UNITED STATES PATENT AND TRADEMARK OFFICE

APPLICATION NO.	FILING DATE	FIRST NAMED INVENTOR	ATTORNEY DOCKET NO.	CONFIRMATION NO.
10/024,784	12/20/2001	Reinhold Wimberger-Friedl	NL 000774	3142

Office Action Summary

DETAILED ACTION

Figure 2 - U.S. Patent 5,866,265 to Reilly et al.

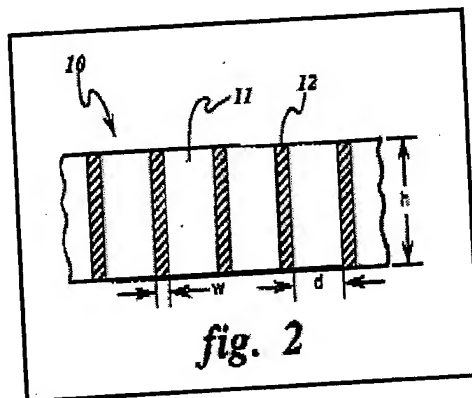
4. As per claim 1, Reilly et al. disclose a method of manufacture wherein material strips having different properties (column 3, lines 5-9; 48-59) are extruded to form regions of a grid structure (Fig. 2, above). Reilly et al. do not explicitly disclose the step of allowing at least one of the extruded material strips to expand in at least one direction such that at least one dimension of the extruded material strips prior to extrusion is restored.

5. Reilly et al. teach however, a step involving the expansion of extruded material strips in at least one direction. Additionally, Reilly et al. suggest as in Fig. 2 above, that the process also include the step of allowing at least one dimension of the extruded material strips prior to extrusion be restored (see "cut" step). By way of example, Reilly et al. teach that such operation results in an ability to successfully duplicate the multiplication process, thereby enabling the construction of several patterned layers to achieve an intended thickness, density or material characteristic (see abstract; column 1, lines 1-31).

6. It would have been obvious to modify the method of Reilly et al. such that it incorporated the step of allowing at least one of the extruded material strips to expand in at least one direction such that at least one dimension of the extruded material strips prior to extrusion is restored. One would have been motivated to make such a modification so that the multiplication process is easily duplicated, resulting in the construction of several patterned layers to achieve an intended thickness, density or material characteristic as suggested by Reilly et al. (abstract; column 1, lines 1-31; Fig. 2 above).

7. As per claim 2, Reilly et al. as modified above, disclose a method of manufacture wherein material strips are co-extruded (Fig. 2, above).

8. As per claim 7, Reilly et al. as modified above, disclose a method of manufacture wherein material strips travel in opposite directions (Fig. 2, above).

at least one dimension of the extruded material strips prior to extrusion is restored. However, Reilly et al. teach by way of illustration (Fig. 2 above), a manufacturing step involving the expansion of extruded material strips in at least one dimension (see "squish" step). Additionally, Reilly et al. also suggest that the process also include the step of allowing at least one dimension of the extruded material strips prior to extrusion be restored (see "cut" step). Reilly et al. teach that such operation results in an ability to successfully duplicate the multiplication process, thereby enabling the construction of several patterned layers.

Figure 2 - U.S. Patent Application Publication US 20020176538 A1 to Wimberger-Friedl et al.

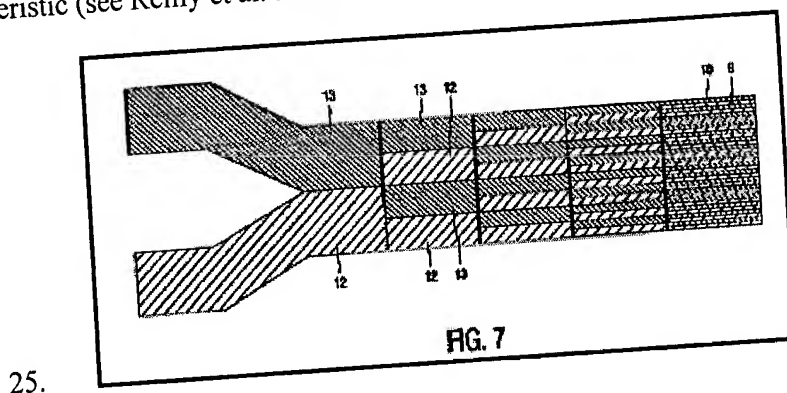
24. Examiner notes that the process disclosed by Reilly et al. provides the framework for the process illustrated in applicants' enclosed drawings (see Fig. 7, below). Examiner contends that the claimed method would be an obvious design choice to a practitioner in the material processing art as a means for producing a material having an intended thickness, density or other material characteristic (see Reilly et al. abstract; column 1, lines 1-31)
